SEWAGE DISPOSAL SYSTEM

MARYLAND STATE DEPARTMENT OF HEALTH*

SUBDIVISION Chris Mar Estates

ROAD 13446 Chris Mar Court LOT 5

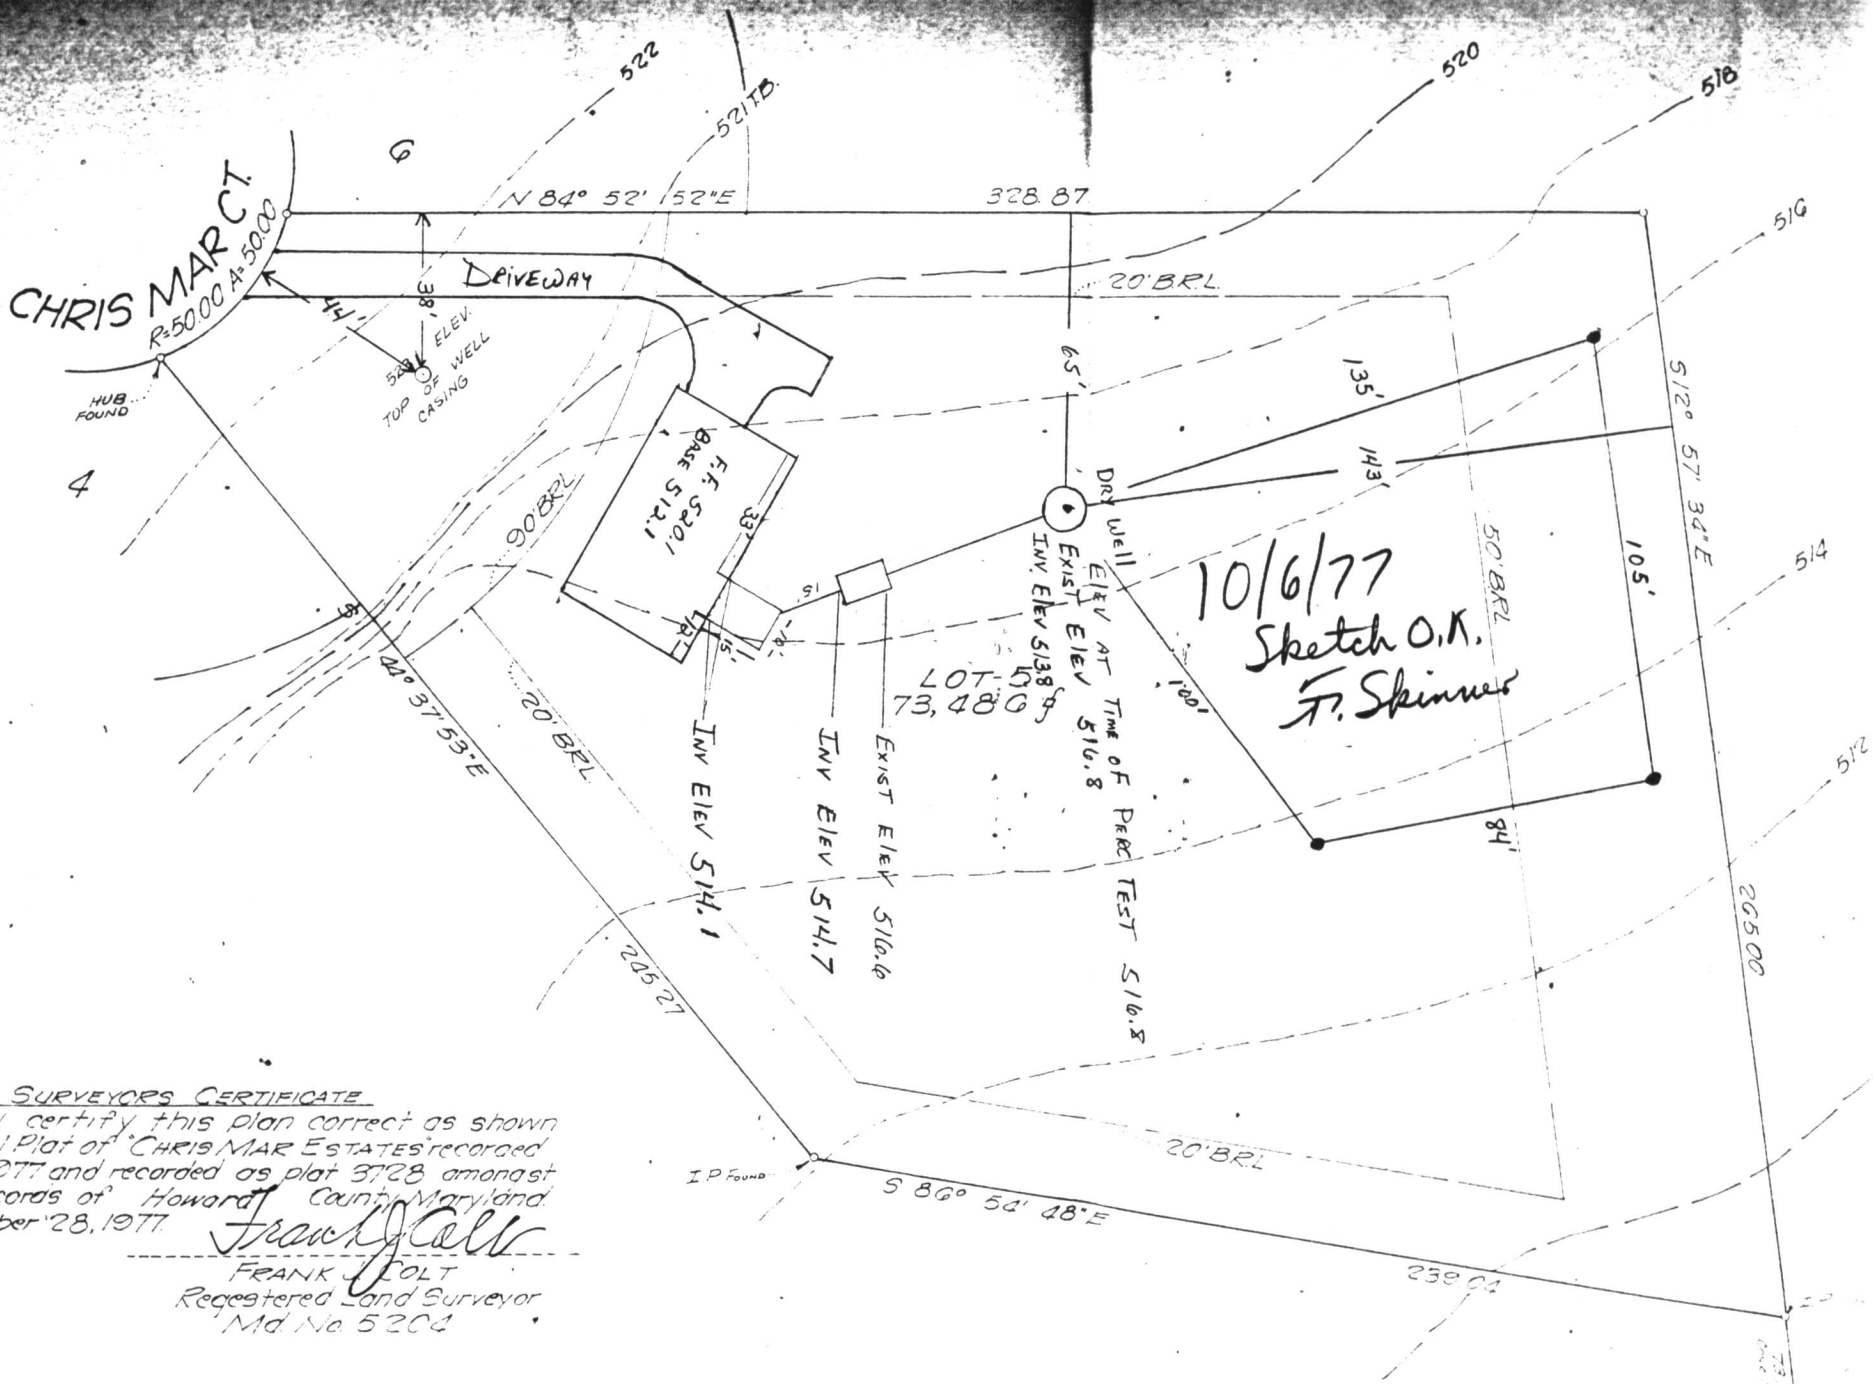
REMARKS OK to put stone in stone, still need to connect house to septic tank and Septic Tank to drainfield. Need to install standpipe and cover on Septic. Call for reinspection. We also need the connection between the two trenches to be nearest the Septic tank. 4/4/78 GMB.
